7.2 Reactor Protection (Trip) System (RPS)—Instrumentation and Controls

The information in this section of the reference ABWR DCD, including all subsections, tables and figures, is incorporated by reference with the following departures and supplements.

Table 7.2-2 Channels Required for Functional Performance of RPS

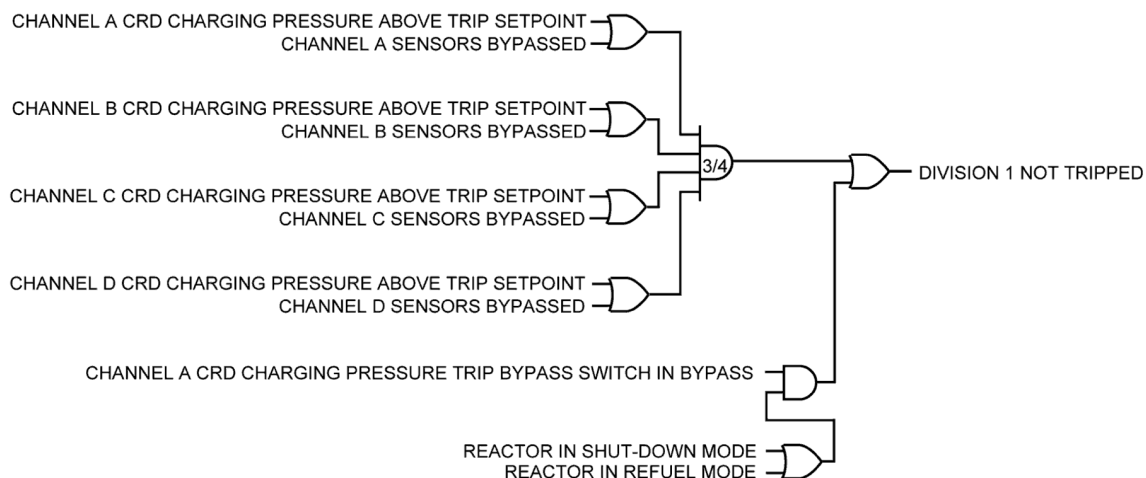
STD DEP T1 2.3-1 (Table 7.2-1, 7.2-2, Figures 7.2-2, 7.2-6, 7.2-9, 7.2-10)

This table shows the number of sensors required for the functional performance of the reactor protection system.	
Channel Description	# Sensors
<i>Reactor vessel low level (Level 3)</i>	4
<i>Main steamline radiation</i>	4

Figure 7.2-6 Division 1 Trip Logic

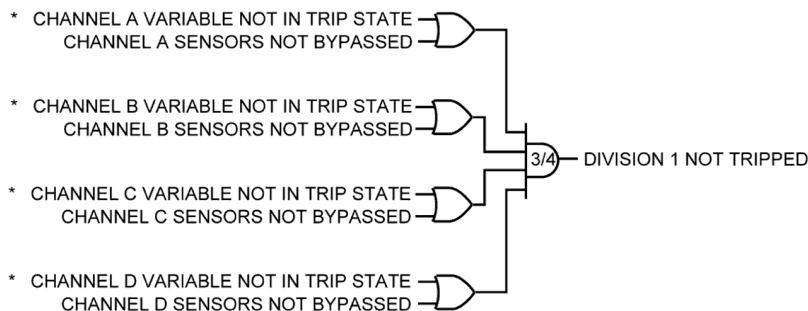
(4) ~~Process Radiation Monitoring (PRM) System (Figure 7.2-6)~~ Not Used

~~High Main Steamline Radiation Trip (Figure 7.2-6)~~

~~A high main steamline radiation trip will occur in each division of trip logic when a main steamline radiation trip condition exists in any two or more unbypassed sensor channels. There are no operating bypasses associated with this trip function.~~

LOW CRD CHARGING HEADER PRESSURE
(TYPICAL OF ALL FOUR DIVISIONS)

- * TYPICAL OF
- REACTOR PRESSURE ABOVE TRIP SETPOINT
 - REACTOR WATER LEVEL BELOW TRIP SETPOINT
 - DRYWELL PRESSURE ABOVE TRIP SETPOINT
 - SUPPRESSION POOL TEMPERATURE HIGH
